Groundwater & Wastewater Services
Septic Project File & Data Review Worksheet

SOIL/SITE EVALUATION for ON-SITE WASTEWATER SYSTEM

IMPROVEMENT PERMIT for a RESIDENTIAL ON-SITE WASTEWATER TREATMENT & DISPOSAL SYSTEM

GWS Septic System Design Review

Scale: 1 inch equals 50 feet	S&ME	Faison - Sample Road LLC	FIGURE
Drawn by: JBP		Lot 67	1
Reviewed by: TCJ		Mecklenburg County, NC	
Date: June, 2007	ENVIRONMENTAL SERVICES • ENGINEERING • TESTING	S&ME Project #1588-05-091

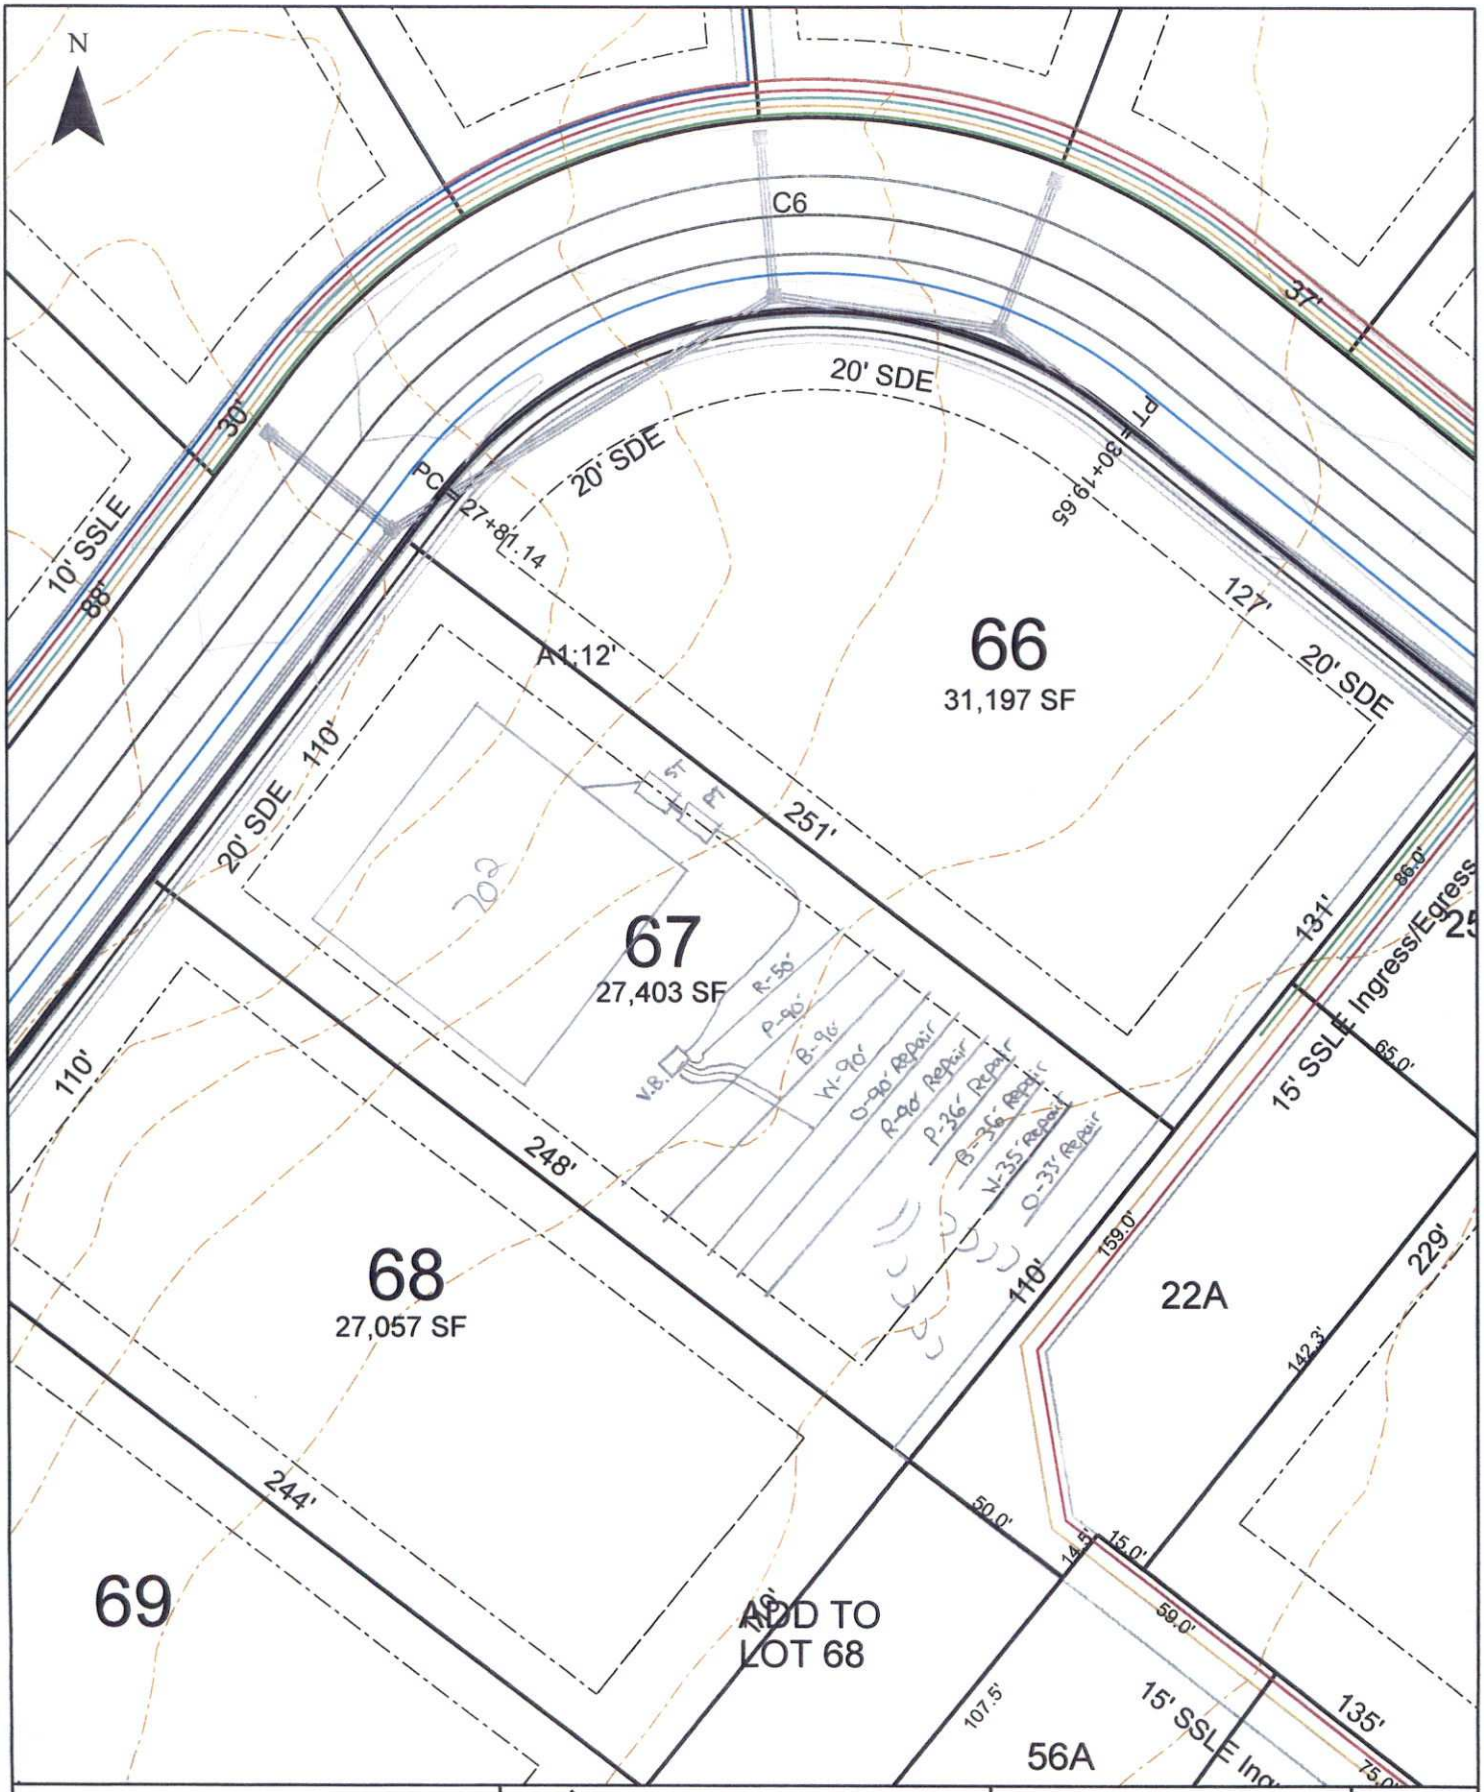
1. Install system using 3 ft. wide trenches.									
2. Install drainlines on 9 ft. centers, level, and on contour.									
3. System design requires effluent pump for distribution.

4. 100% Repair area is required.
